# 1990 Corvette: Service Bulletin: Information on Door Lock System Components and Replacement Components

**Subject:** INFORMATION ON DOOR LOCK SYSTEM COMPONENTS AND REPLACEMENT COMPONENTS

**Model and Year:** 1990 CORVETTE

**Bulletin Number:** 90-375-10 - (10/25/1990)

**Figure 1**

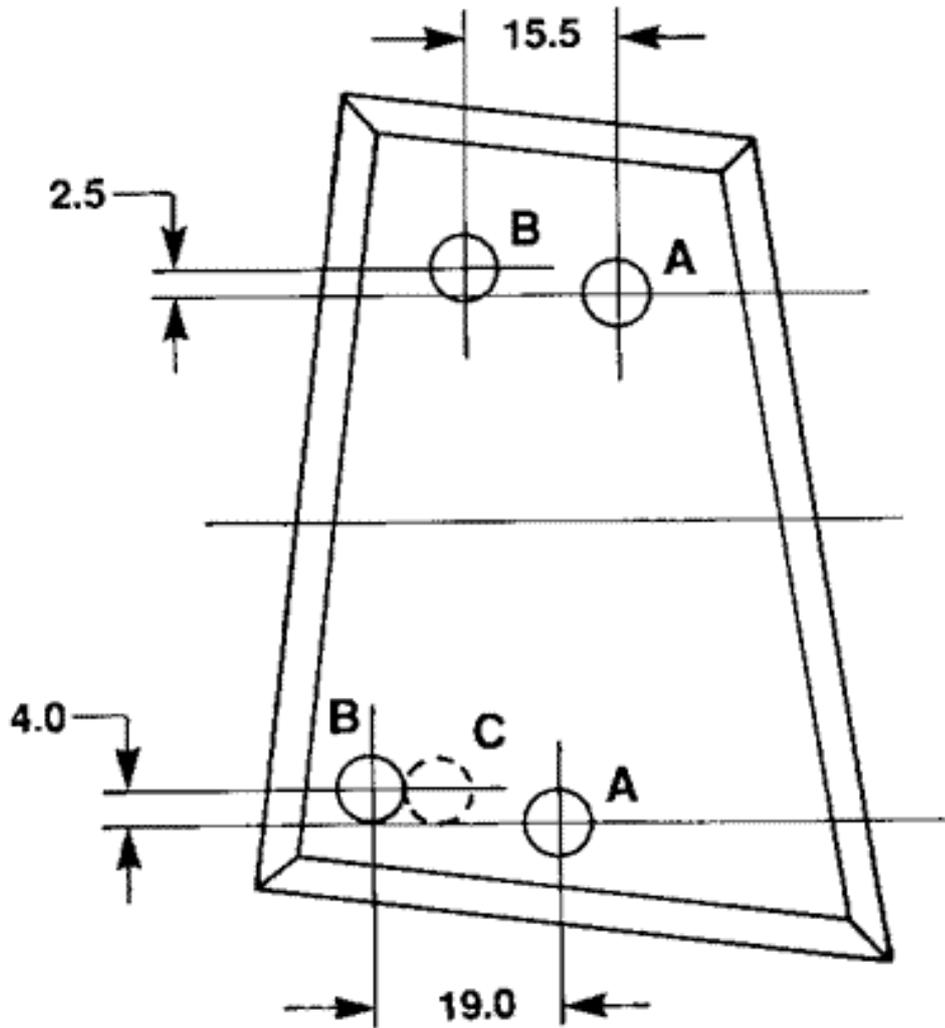
In addition to replacing the above components, it may be necessary to relocate the power door lock actuator on the door inner panel. Figure 1 will illustrate the hole patterns.

- If the actuator is located in the holes marked "A," it will not need to be relocated.

- If the actuator is located in the holes marked "B";
- remove the actuator by drilling out the attaching rivets.
- locate the new attaching holes ("A") using the dimensions on the illustration.
- attach the actuator in the new location using 1/4" X 1/2" peel type rivets.

**IMPORTANT: Hole "C" may or may not be present. Relocate holes from "B" locations only.**
